I-95 & SR 896 **INTERCHANGE PROJECT**

I-95 AND SR 896 INTERCHANGE PROJECT VALUE ENGINEERING STUDY

DelDOT Contract No. T201609002

Delaware Department of Transportation

Figure 9: Shared Use Path on Ramp D

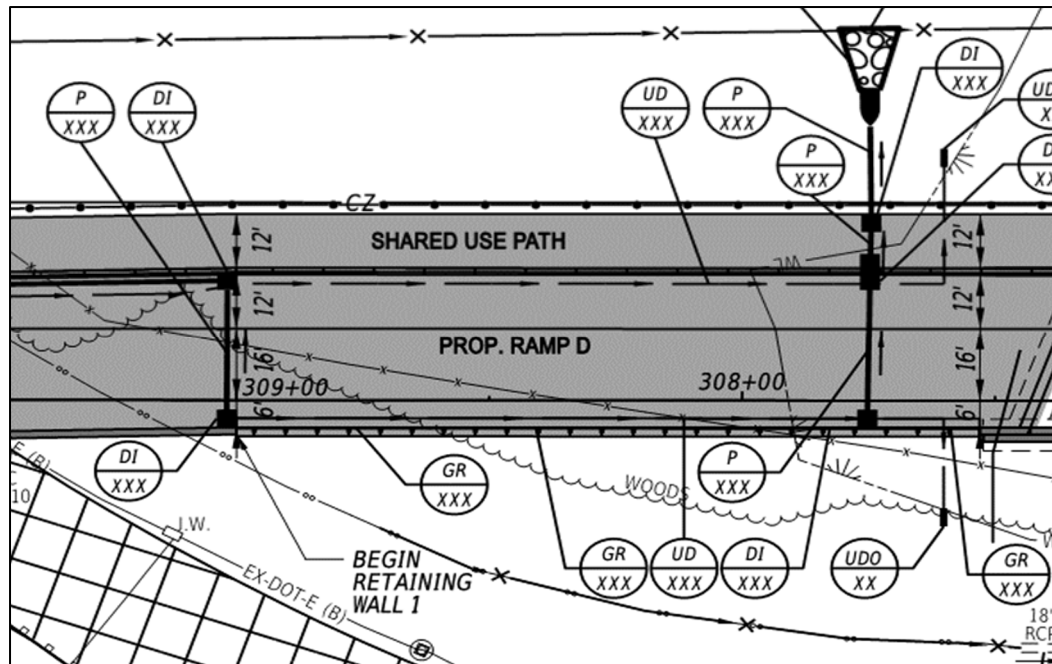
The VE Team discussed the shared use path along Ramp D and asked whether it tied into an existing path on SR 896 or included connection access to Old Baltimore Pike. The Design Team noted that the Ramp D shared use path is intended to tie into a not-yet-constructed connection to Old Baltimore Pike proposed in a separate widening project for SR 896 south of the Interchange Project. The existing shared use path connections in the vicinity of SR 72 were also discussed. The Design Team indicated that it considered the existing shared use network around Route 72, but feedback indicated that incorporation of a shared

used path across I-95 was of high public priority for this project. The VE Team concluded that the shared use path should remain on Ramp D and proposed it could be reduced from 12 feet to 10 feet to provide a practical design that meets AASHTO requirements. Figure 9 shows the proposed path width between Bridges 1-649B and 1-703C. The 12-foot width is proposed for over ½ mile or nearly the entire length of the path starting at SR 896 leading into Ramp D, approaching Bridge 1-649B, and continuing through Ramp D across Bridge 1-703C. The shared path splits off from Ramp D just prior to Bridge 1-703D and continues at a 12-foot width for approximately 500 feet before narrowing down to 10 feet to tie into SR 896.

The VE Team estimates that reducing the path width can save up to \$250 per square foot across bridge structures and \$90 per linear foot across at-grade sections. The potential savings was estimated as follows:

Figure 10: I-95 Lane Configuration at Ramp F Tie-in

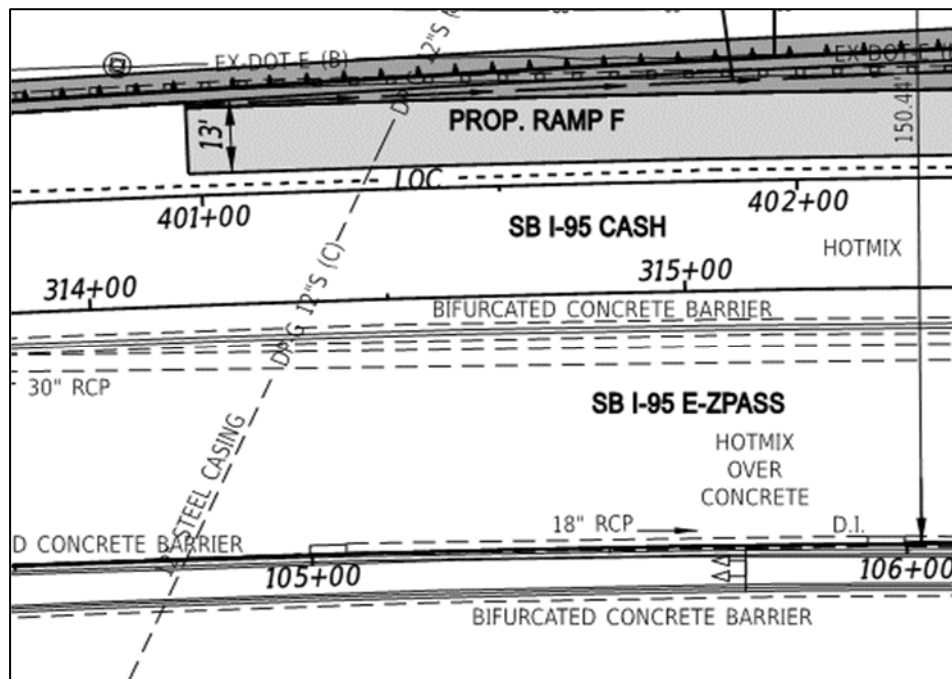
Regarding maintenance of traffic, it was discussed that the Welcome Center located north of the interchange is located in the median of I-95 with entry and exit points on the left, opposite of the SR 896 interchange access points. Also, the configuration to access the Newark Toll Plaza located south of the interchange includes bifurcated concrete barrier to separate EZ-pass only lanes, which divides the existing mainline lanes prior to the proposed Ramp F tie-in. Figure 10 shows the toll lane configuration on I-95 at the proposed Ramp F tie-in south of SR 896. These conditions provide added challenges to maintain safe and adequate access for motorists and construction vehicles during construction.

Figure 11: Proposed Phase 3 Girder Setting

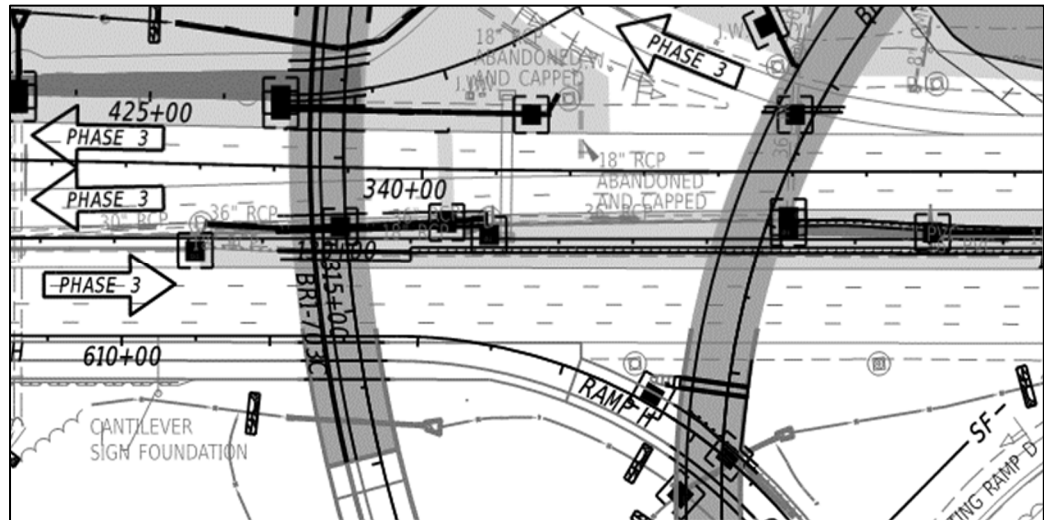
This phasing would result in earlier relief of the congestion point for traffic merging onto 896 southbound from I-95 southbound while giving the contractor a larger area of work to access and enabling more efficient construction to reduce the overall construction time. It does not provide for the benefits associated with progressing the northbound and southbound widening in a single phase, which is addressed later in this section as a separate alternate phasing option. It also does not allow for the benefit of girder setting at Ramp C and D across I-95 in a single phase as proposed in the current phasing plan. Figure 11 shows the proposed coordinated phasing of girder setting across I-95 in Phase 3.

Figure 12: Phase 2 Proposed Southbound Widening

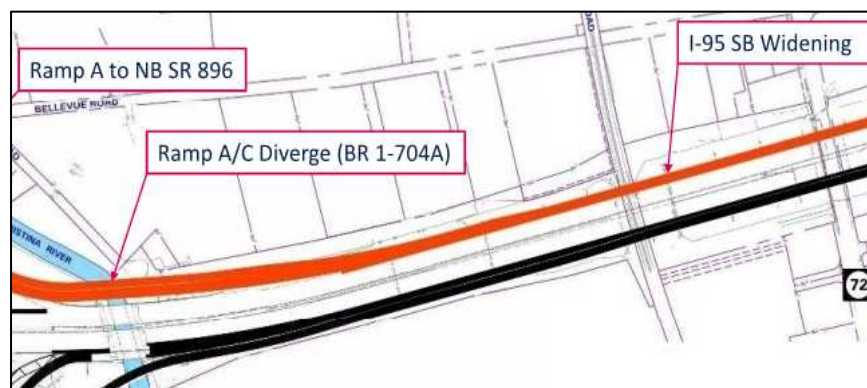
Another phasing option discussed was allowing the northbound and southbound widening to progress in the same phase. It was noted that the current proposed widening in Phases 1 and 2 could progress concurrently rather than sequentially with an interim stage milestone for the opening of Ramp A to avoid potential conflict between Ramp C construction and the temporary Ramp A alignment.

One significant benefit of sequencing this widening together during an early phase is that it would enable earlier access to Bridge I-706 over Norfolk Southern, which may be difficult to construct due to the existing structure foundation and associated railroad constraints for this work. The Team recommends phasing this bridge work as early as possible to allow more opportunities for mitigation should delays be incurred. Figure 12 shows proposed Phase 2 southbound widening to occur following completion of the proposed Phase 1 northbound widening.

Figure 13: Rendering of Existing Pile Layout at 1-706

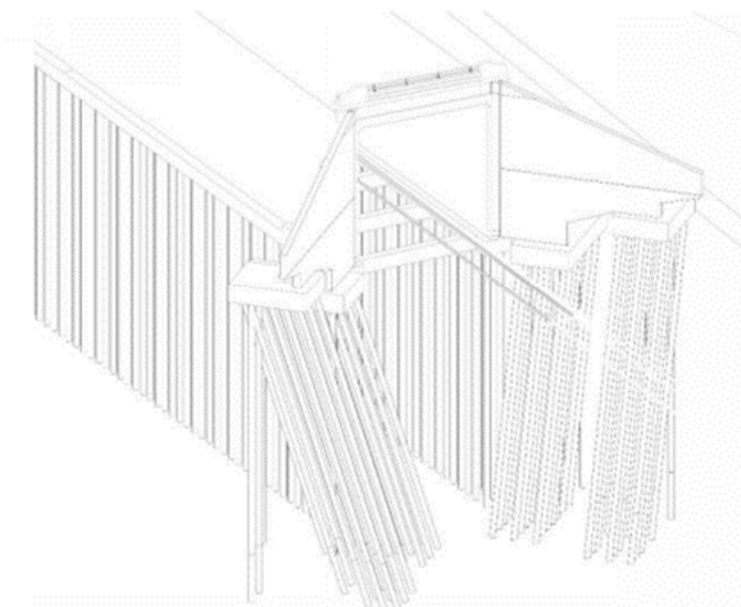
The VE Team recommends reducing the number of drilled shafts by considering micropiles as an alternative for the foundation for the widening of the Structure 1-706 over Norfolk Southern. There are several existing piles and battered piles that will likely cause conflict during the proposed drilled shaft caisson installation. Figure 13 shows the rendering of the existing pile layout at Bridge 1-706.

At a minimum, the VE team recommends that subsurface exploration is performed to verify that conflicts with existing piles can be avoided with the drilled shaft concept. Use of micropiles may provide added flexibility therefore reduced costs in overcoming these conflicts as compared to a drilled shaft caisson. Additionally, the equipment required for the drilled shaft construction may be difficult to maneuver around the high mast electric lines. The VE Team agreed that the cost of micropile foundations versus drilled shaft foundations is relatively comparable. DelDOT Contract T201407601 included Item No. 619520, Drilled Micropiles, which was bid at \$200 per linear foot. Associated load testing was bid at \$2000 per test. Assuming that it would require approximately four micropiles to achieve a capacity comparable to a 42-inch drilled shaft caisson, the relative cost of micropiles is estimated at \$800 per linear foot compared to \$1300 per linear foot estimated for a 42-inch drilled shaft caisson. When the cost of load testing is factored in, the initial price of micropiles may be comparable or slightly higher compared to caissons, depending on the number of load tests required, but field changes may be less costly to address with micropile foundations. Therefore, for purposes of this evaluation, the VE Team assigned a

4. Micropiles on Bridge 1-706 – Implementation Committee agrees with project team to analyze the use of micropiles on Bridge 1-706 to determine if the change in foundation type is a better alternative. Final recommendation will be coordinated with DelDOT Bridge Design.

Figure 15: Existing 36-in RCP Crossing and Proposed 18-in RCP in Median

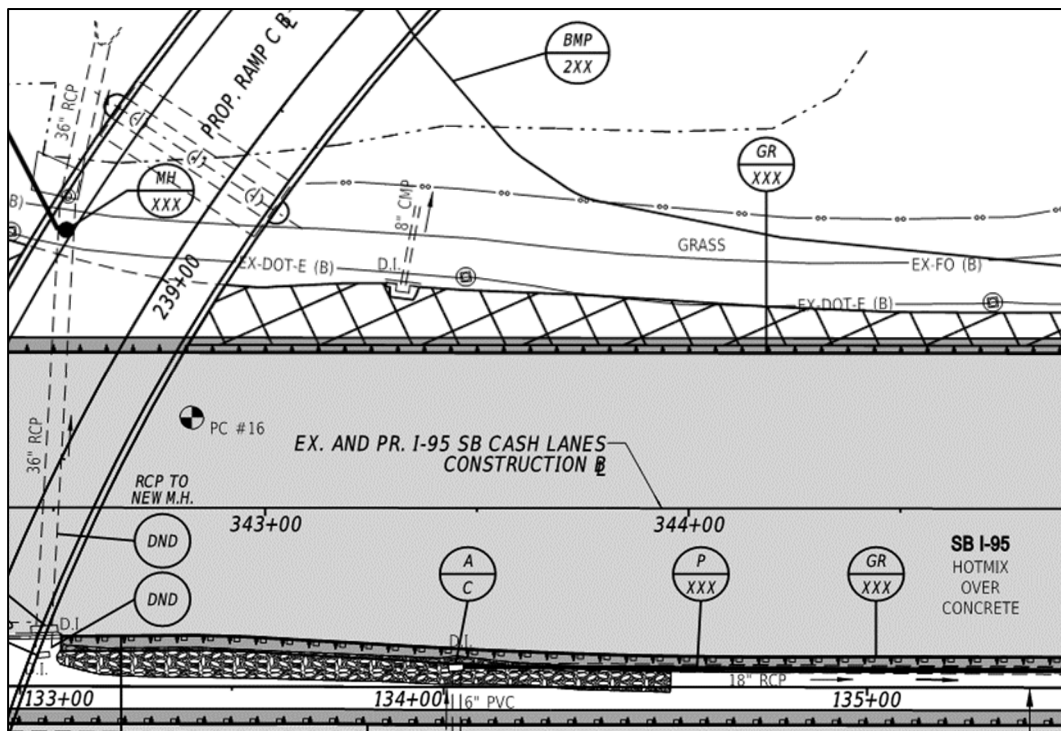
Figure 15 shows the existing 36-inch RCP crossing and the proposed 18-inch drainage in the median that connects into the proposed 18-inch drainage crossing at approximate station 345+40 and drains into the Ramp C infield.

Figure 16: Ramp J Guardrail

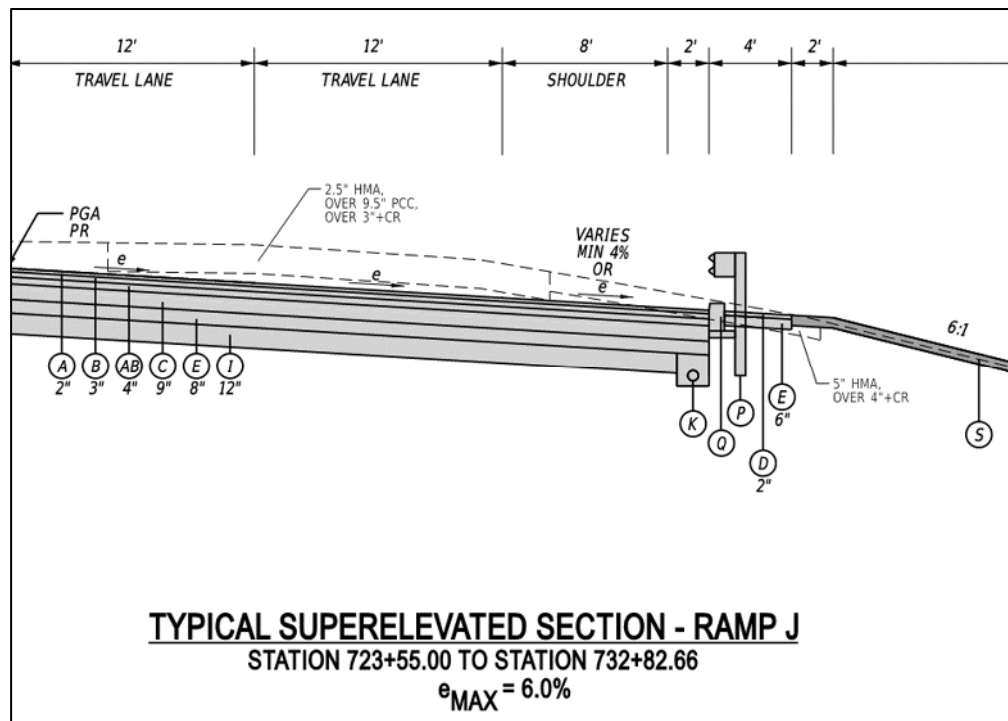
Figure 16 shows the typical section at Ramp J including guardrail for Station 723+55 to Station 732+82

Figure 17: Potential Laydown Areas

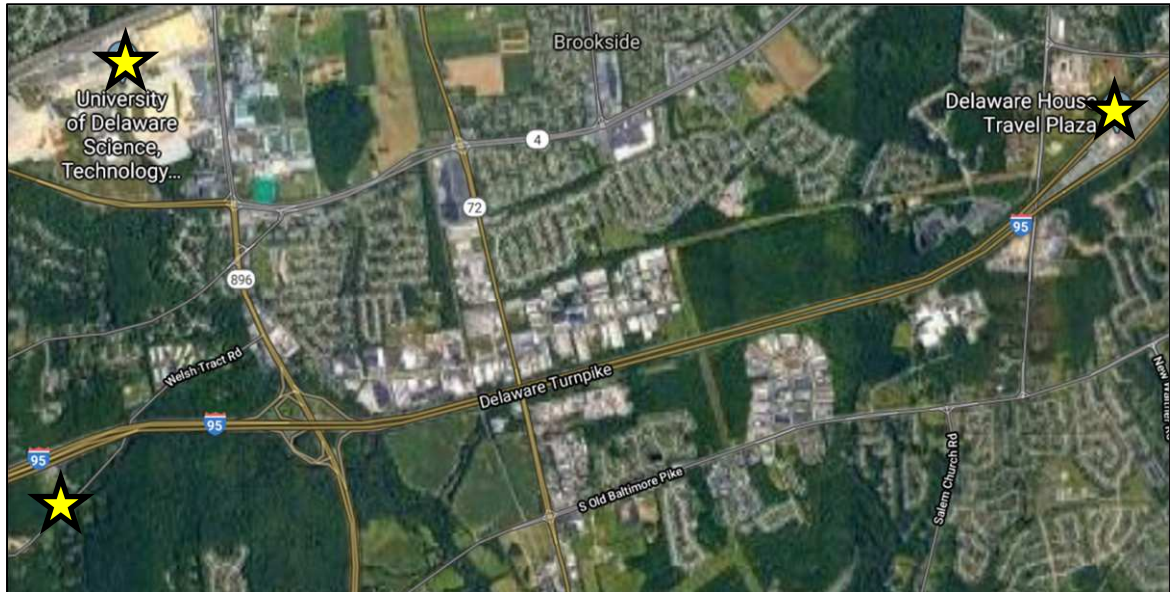
The VE Team discussed a potential laydown area near the Welcome Center east of the project site. There is also potential space at the University of Delaware Star Campus on Discovery Boulevard located adjacent to the University of Delaware Science, Technology and Advanced Research Campus. Finally, the VE team discussed potential laydown area behind the Delaware E-Z Pass Service Center. Figure 17 shows the location of these potential laydown areas in relation to the I-95 and SR 896 Interchange. These sites are in close proximity to the project and would be beneficial especially if the maintenance of traffic for I-95 is such that limited lay down areas within the project limits are available.

Figure 18: Proposed CMP Piping at Ramp C

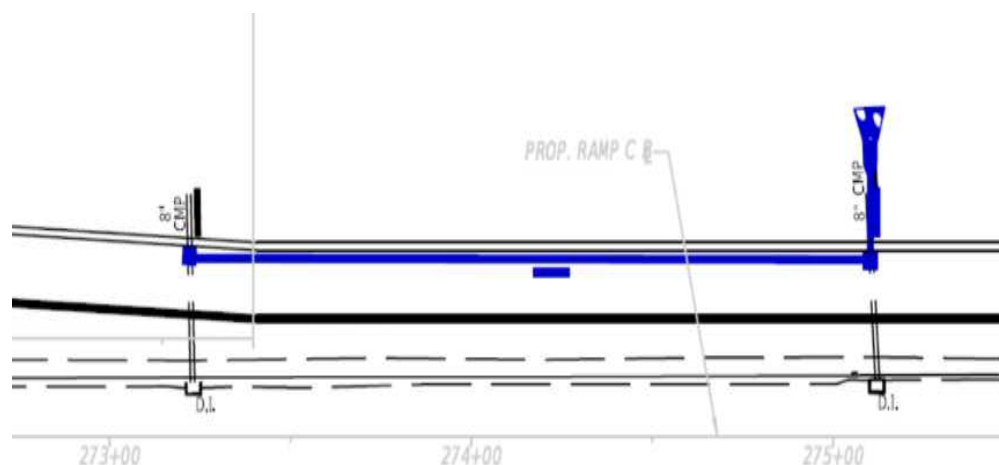
The VE Team noted that the existing CMP piping is being utilized in the proposed design at Ramp C (See Figure 18 below). The VE Team recommends that the Design Team confirm the proper conditions are met to use the existing piping and consider including maintenance tasks such as pipe lining in the bid to enhance the lifespan of the pipe and reduce the risk of delays during construction due to deteriorated condition on the existing pipe.

Figure 19: Underdrain at Ramp H

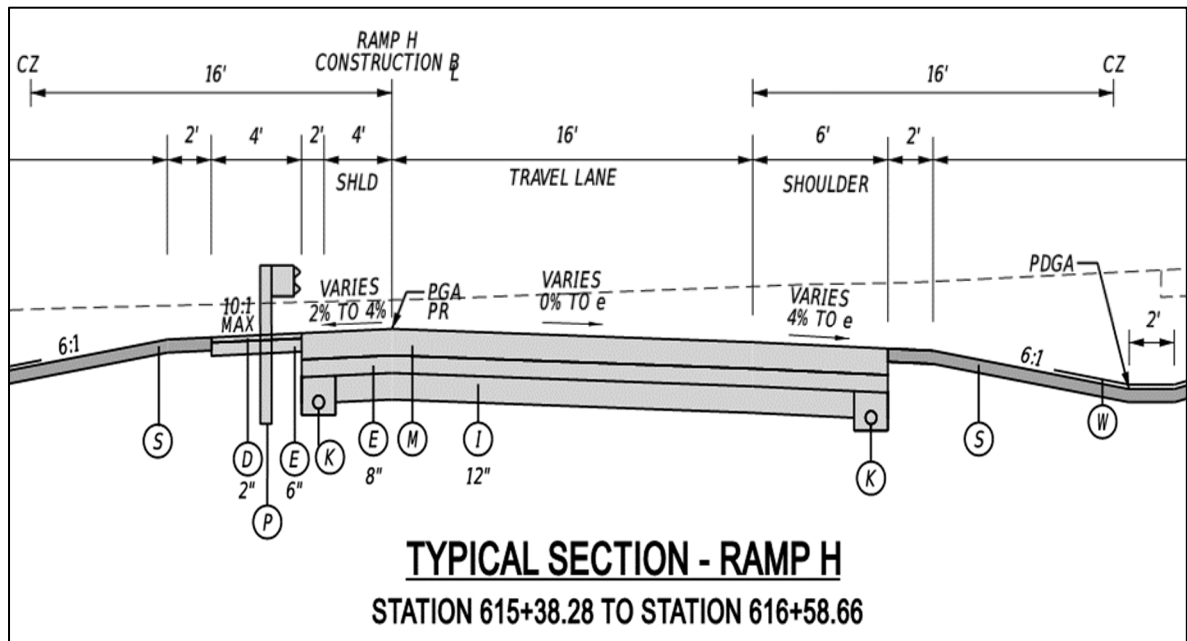
The VE Team noted that underdrain is called for on both sides at Ramp C, Ramp F&G and Ramp H. The Team noted that certain runs of underdrain will not provide much benefit including the underdrain on the high side of the cross slope for Ramp C and the underdrain on the 4-foot shoulders at Ramp F&G and Ramp H (See Figure 19). It is recommended that underdrains with minimal capture potential be reviewed for possible elimination.

Figure 20 – Super Silt Fence

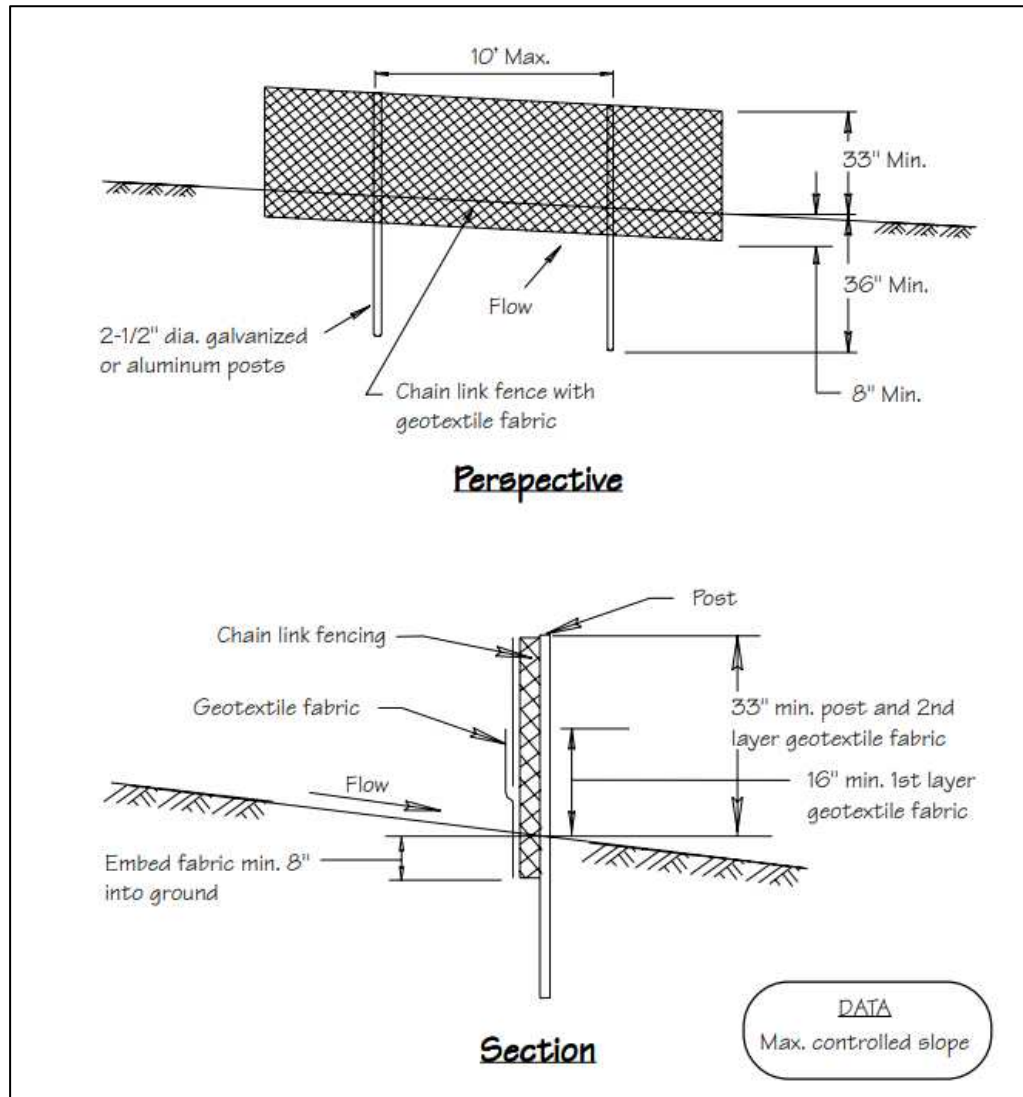
The VE Team recommends the Design Team include in the preliminary cost estimate a line item for super silt fence (See Figure 20) around bridge areas or clarify the suggested line item is part of the lump sums in the bridge section.
